**REPORT ON  
INDEPENDENT ANALYSIS  
AND ADVICE REGARDING  
THE SAFETY CASE 2015**

**Doel 3**  
**Reactor Pressure Vessel  
Assessment**

V1 03 November 2015 •

Figure 1: Evolution of the rejection thresholds between 2012 and 2014

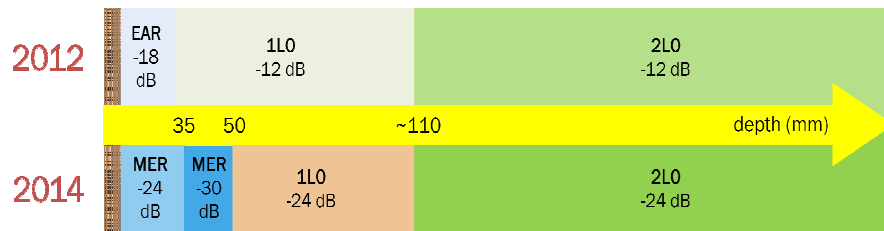
The SCP Review Team pointed out that the rejection threshold has to be selected in such a way that a high confidence level would be ensured for the detection, regardless of the effect of the faceting or other geometrical elements. The SCP Review Team requested that a confidence level of 95% should be reached corresponding to the best practices in that domain.

The SCP Review Team questioned the Project Team regarding the selection of the sensor used to perform the UT examination of the first mm of the core vessel, just behind the cladding. Two sensors could have been used: one MER and one EAR.

The Project Team answered positively to that request and consolidated the qualification process at a very high level of confidence (above the SCP Review Team’s expectations).

The final consolidated results of the qualification confirmed that the MER sensor provided a level of performance similar to the EAR but that its response was better at near depths inside the material (especially <30 mm). At higher depths, the rejection threshold has been lowered to maintain the detection capability.

**Figure 5: Indication size distributions (UCS: Upper Core Shell; LCS: Lower Core Shell) based on the 2012 or 2014 methodology with the 2012 raw data**

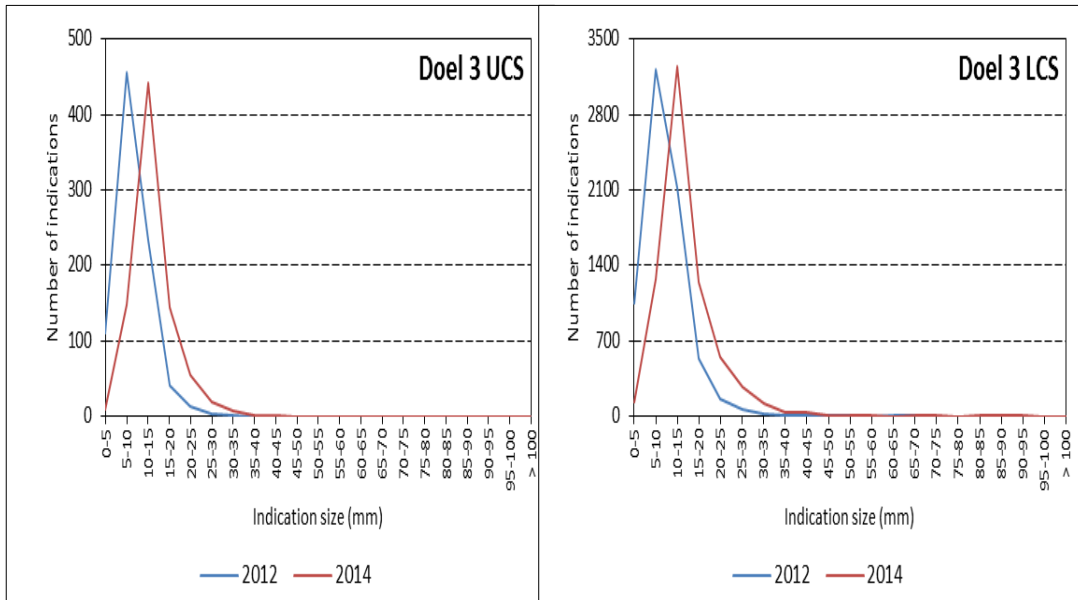
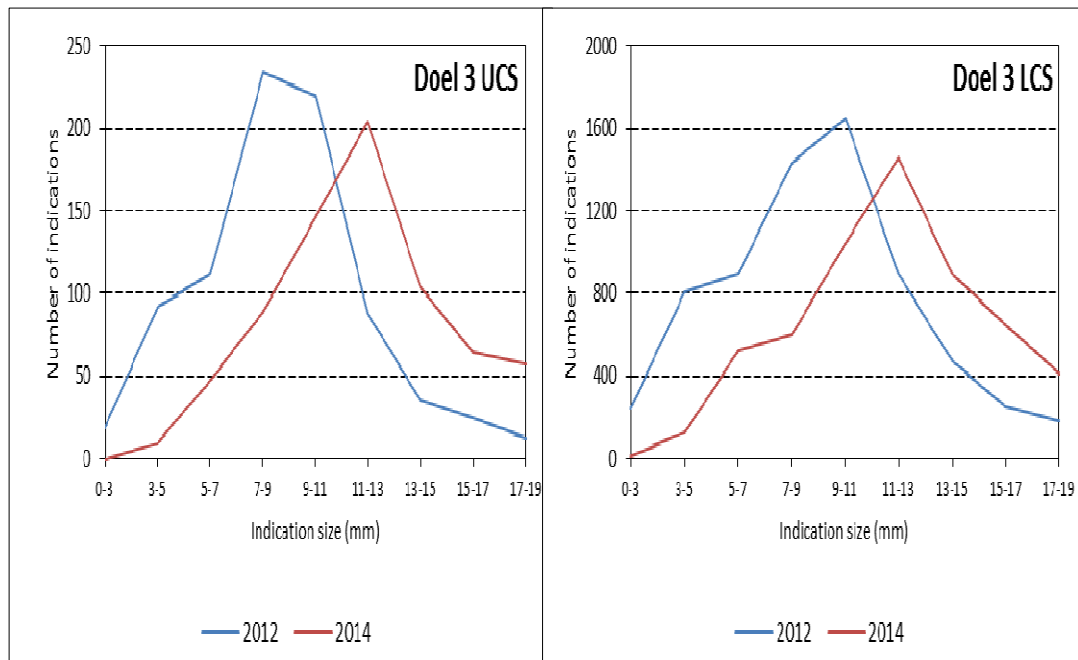
Since the continuous improvement of the qualification led to a new rejection threshold in the 2014 methodology, the SCP Review Team requested that the Project Team re-analyse the 2012 raw data set using the 2014 methodology (the echo-dynamic sizing), in addition to the analysis already performed with the 2012 methodology (the historical 6 dB drop sizing). On one hand, this action aimed at demonstrating that no evolution of the indications occurred between the inspection of 2012 and the inspection of 2014. On the other hand, it enabled establishing a better reference point (2012 inspection) for the comparison with any potential further examinations.

In answer to this request, the Project Team provided improved statistics summarized in Table 4 and illustrated in figures 5 and 6.

**Figure 8: Distribution of the number of indications with respect to the depth—VB395/2A**

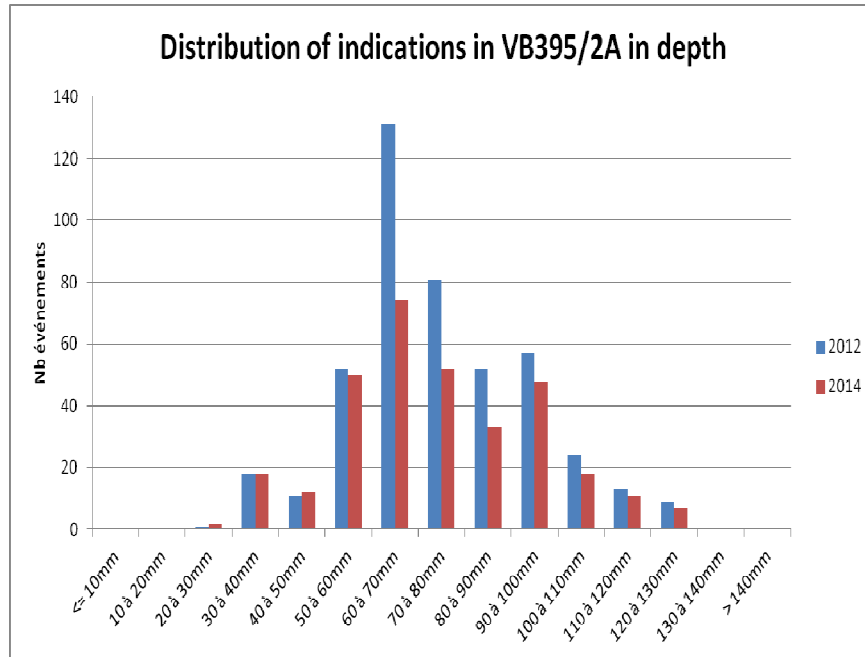
After the presentation of those results, the FANC requested complementary information aiming at clarifying whether the same exercise of reanalysis with the 2014 methodology was done on the VB395/2A block used for the qualification and on which measurements were performed in 2012.

The reanalysis revealed that the same behaviour was observed on the VB395/2A block: a reduction of the number of indications but an increase in size (Figure 8, Table 9)<sup>1</sup>.

**Figure 10: Normalized histogram of the delta in DZ sizing (usual sizing—alternative sizing)**

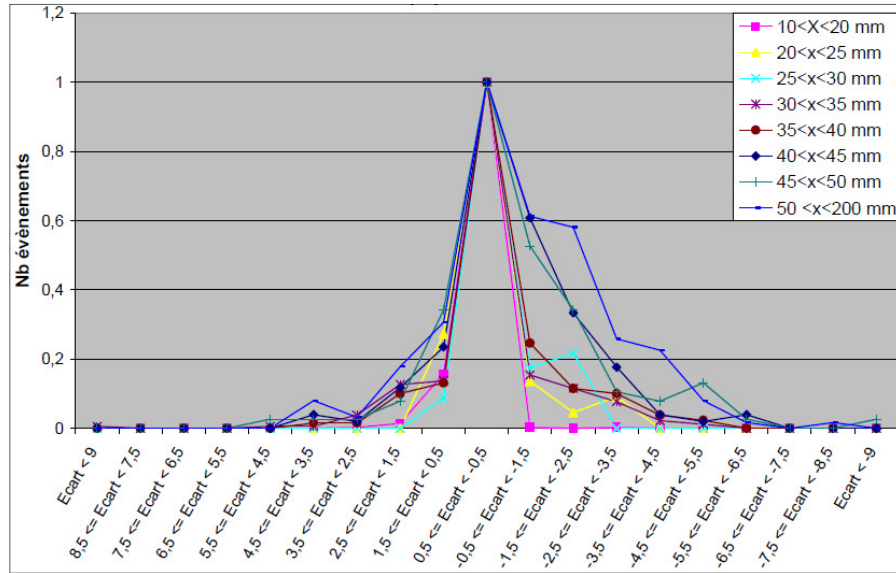
In order to challenge this conclusion, AIA requested that complementary comparisons between the two methodologies be performed, with no destructive test, on the lower shell of the Doel 3 RPV. The following comparisons have been performed:

It appears that the results are equivalent up to 20 mm. For the largest indications, it can also be concluded that the 'alternative' methodology gives statistically larger dimensions in DZ.
